Greater Cambridge Share Planning Service

23/08/2022

Response to 22/02814/FUL: 19 High Street Grantchester for replacement dwelling

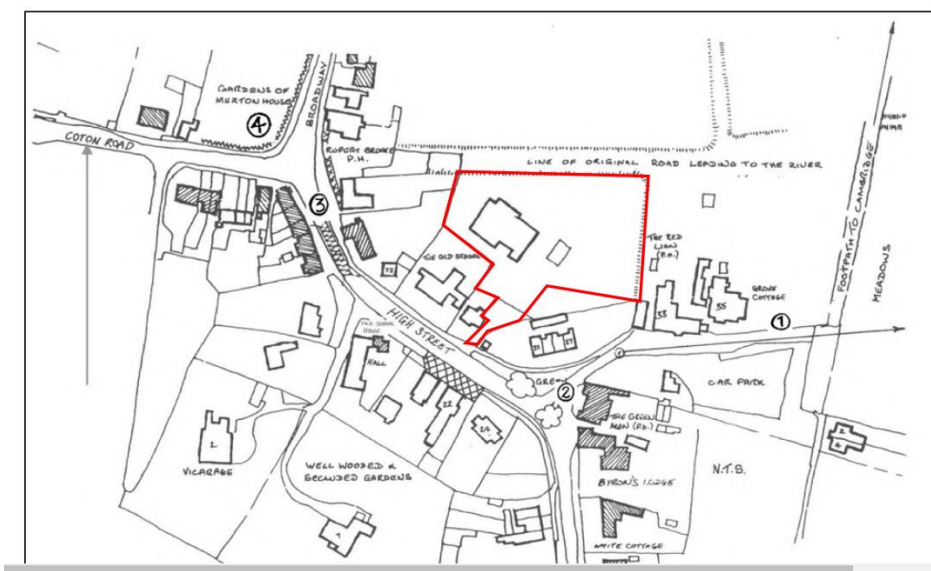
Screening: That the building would be at least partially screened by vegetation seems to be one of the justifications being used for allowing a building which is at odds with the Conservation Area. However, we have noted that two large trees which help to screen the site from the High Street are ash trees (see photo

below). Due to the high risk that they will succumb to Ash Die-Back disease within a decade, the new building should really be considered as though these trees have gone – in other words being much more visible and having a greater impact on the Conservation Area. Even if replacement trees were planted, it would be 30 years before they reached a sufficient size.

Block plan indicating site extending across the Roman Road

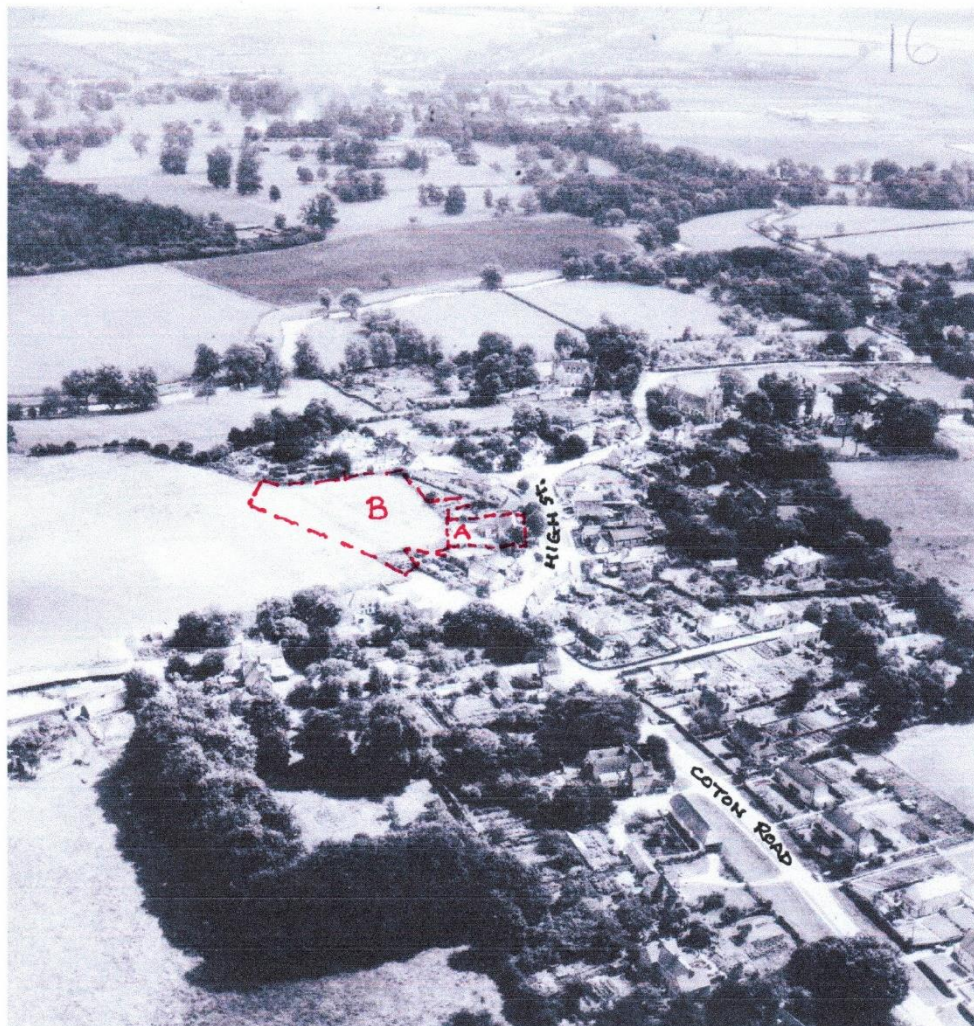
Please refer to the plans on the following page. The plan from page 3 of the D&A Statement indicates the line of the road as being outside the site area as indicated by the red line, however the Planning Application Block Plan indicates the existing fence line retained and the road contained within the garden.

The process for reclaiming the ancient road as a right of way has been started through the Ramblers Association 'Don't Lose Your Way' Campaign. A pragmatic way of resolving these issues might be for the applicant to agree to a realignment of the North boundary of the site so that the ancient road is returned to Grantchester Meadows. If this was done the siting of the building would need careful consideration as would the screening of it from the meadows.
